# Delaware Basin Changes to APD for Federal Well

# Well Names:

Salado	Draw	29	26	33	#5H	API#:	30-025	42440
Salado	Draw	29	26	33	#6H	API#:	30-025	42441
Salado	Draw	29	26	33	#7H	API#:	30-025	42242
Salado	Draw	29	26	<b>33</b>	#8H	API#:	30-025	42243

### Summary of Changes to APD Submission

### Batch Dilling Sequence

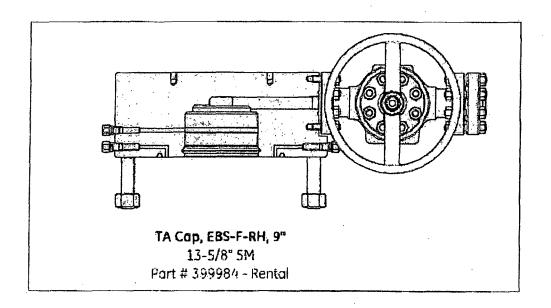
**Summary:** Variance to batch drill the Salado Draw pad not requested in original submittal.

#### As Defined in APD:

Variance to batch drill not requested.

#### As Planned on Well:

Chevron respectfully request the ability to batch drill in the SALADO DRAW 29 26 33 PAD. The summary provided is a brief description of the main operational sequences for drilling and casing the four wells listed.
